Title: Northstar Accelerator Based Mo99 Production Facility Design Support

LANL FY20 final Facility Design Support Report

Figure 2. The current target design, also comprised of individual disk holders stacked in a body. In this design the U-shaped holder part can slide outward to open up the coolant gap and release the disks.

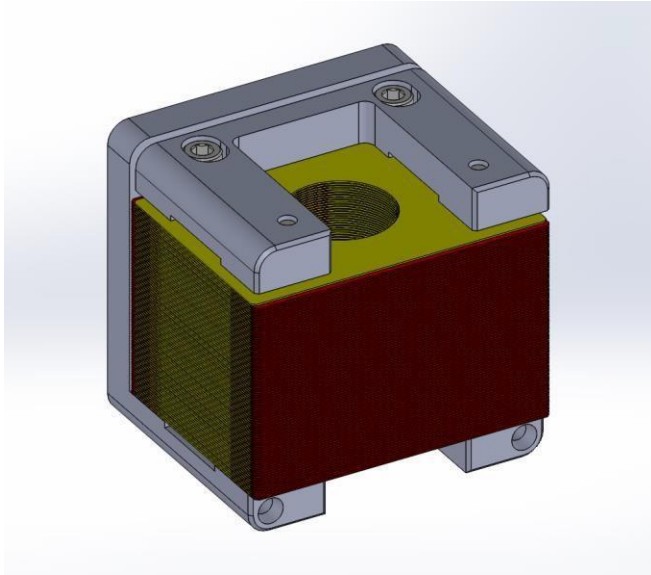
Currently, the plan is to proceed with a design developed by MBraun/Springs which incorporated a separation motion that in principle allows the disk to drop out of the holder while leaving the steel holder parts within the holder body. This is shown in Figure 2. As shown in the figure, this concept requires a rather thick yoke piece. The result is that the window is now some distance from the target housing. This has serious impact on several aspects of the design. First, there is a high heat load in the yoke itself and at present no means to remove that heat. Second, the window is cantilevered off of the housing, and then the cantilevered cylindrical part is bolted to the housing. There is 5 kW thermal in the flanges on each window (10 kW total) with no cooling. These are radical and very high risk changes to the baseline design. Thermal cycling of the flanges holding the window will certainly lead to helium leaks into the beamline. The wider target holder configuration also impacts the diameter of the target insertion pipe, increasing weight and adding complexity to the handling of the larger part. Radiation streaming control is also more difficult.

Figure 8. Current conception of the local target shielding, contractor design.

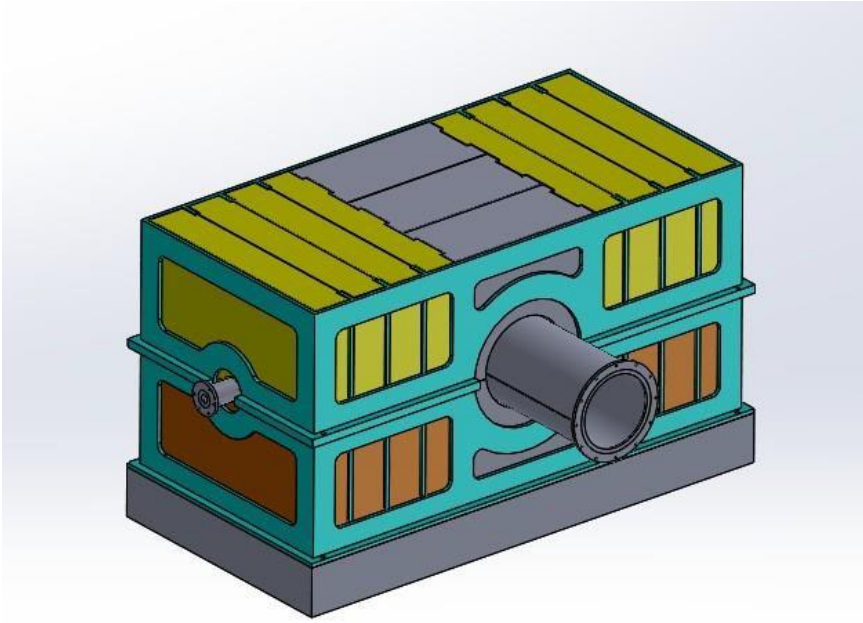
LANL has advised to not interlock the boxes. Radiation shine paths perpendicular to the beam are of secondary importance, and the narrow gap between boxes can be filled with lead or steel wool or matting.

More important however, is that the large number of boxes, and the vertical stacking, makes the water cooling rather complex. LANL suggestion is to install larger boxes with a flow distribution baffle at the bottom, then place steel plates vertically, with gaps between for cooling. Water would flow from bottom to top, also improving the removal of any gases generated by radiolysis. This would introduce radiation streaming paths normal to the beam. This could be accommodated, if necessary, by additional bulk shielding at the wall.

Figure 9. Cross section view of the target, as currently configured, with window bolted on to the housing.

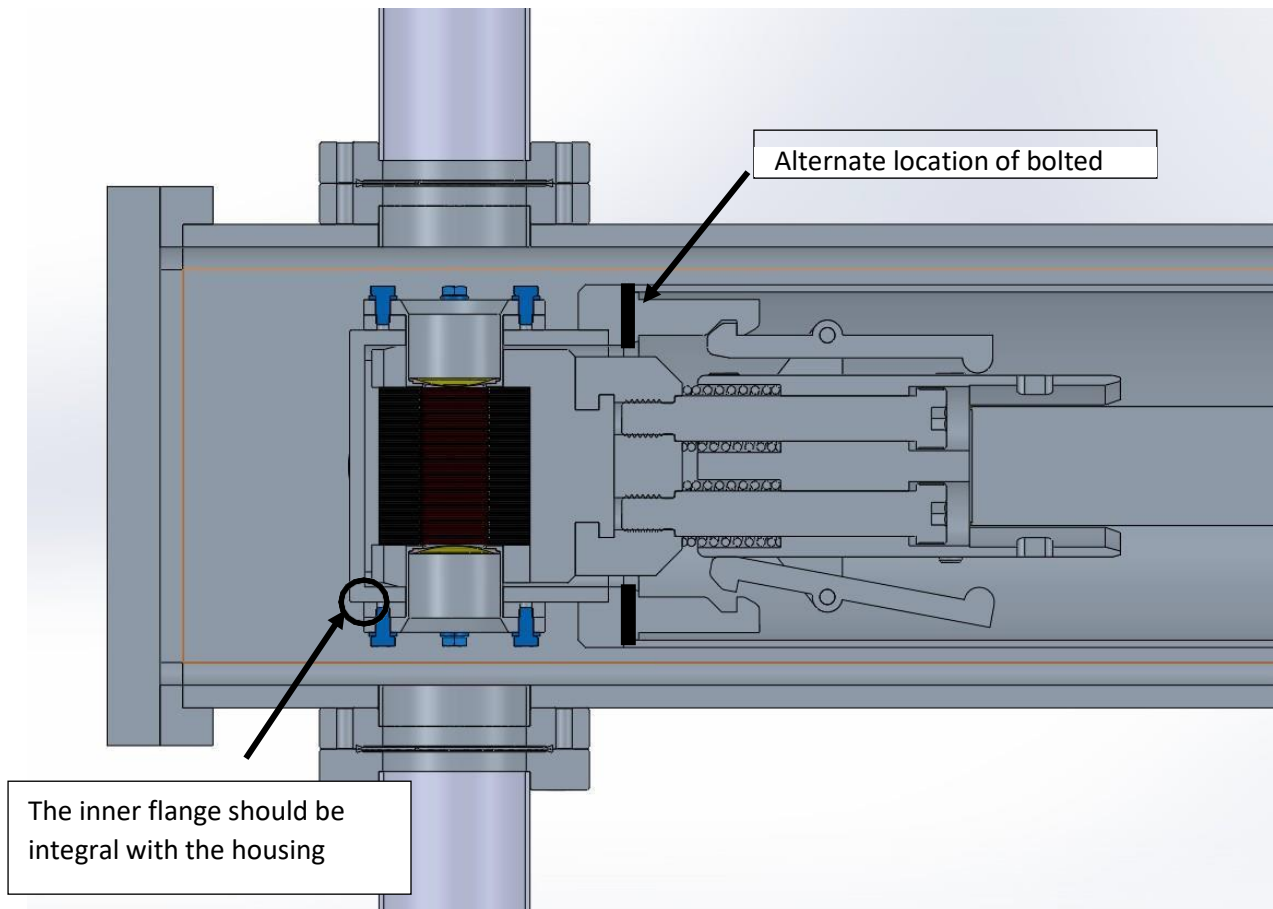
Figure 9 shows a cross section view of the target, with beam pips entering from the top and bottom. The current design has the windows screwed to the housing rather than welded. This will be difficult or impossible to adequately cool. Thermal cycling in this region will loosen the bolts over time. The windows should be welded to the housing and the bolted joint moved away from the high beam energy region directly in line with the target. If the bolted on window remains the preferred solution, the inner flange piece, currently envisioned as welded on, should be a machined feature of the housing, significantly improving thermal contact and facilitating cooling. As stated above, there is a very high heat load in the yoke and the target flanges that as yet has no cooling

Also in Figure 9, the target insertion mechanism remains in close proximity to the target during irradiation. Also, the containment pipe is in vacuum. Helium is flowing through the target and therefore fills the target insertion pipe. Some small fraction of the total helium flow should be directed down the target insertion pipe for cooling of these components.

Figure 10. Cross section view of the target through the helium supply route.

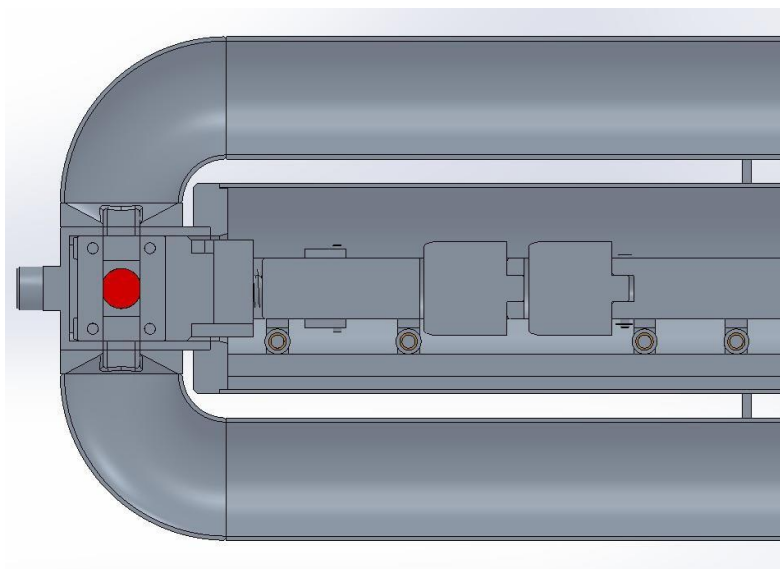
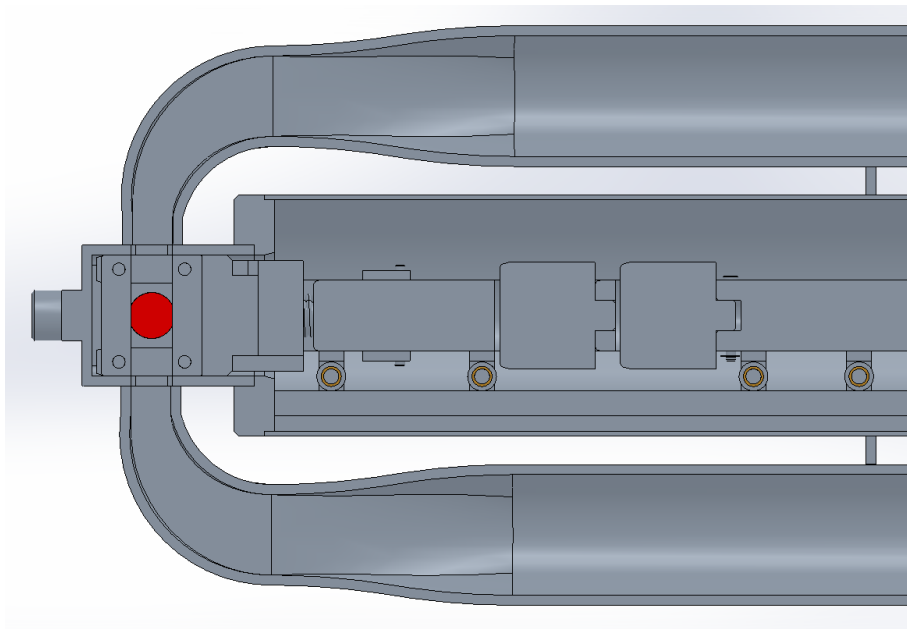
The target cross section view through the helium cooling lines, as currently conceived, is shown in Figure 10. The primary concern here is the rapid transition from round pipe to the rectangular flow channel necessary for flow through the target. This will result in unnecessary pressure drop, and a very turbulent flow entering the target, with regions of flow separation and recirculation. The recommendation is to extend the rectangular section of pipe around the bend and to make a smoother transition from the round to rectangular. Also, the helium pipe diameter has been increased from 2" to

3". While this reduces pressure drop along the long run from and back to the blower, it requires a larger target insertion pipe and requires more difficult or space consuming radiation shine path reduction.

Northstar proposed a variation on the rectangular elbow that includes a gradual transition to the round pipe. This is shown in Figure 11. These variations have been incorporated into the design.
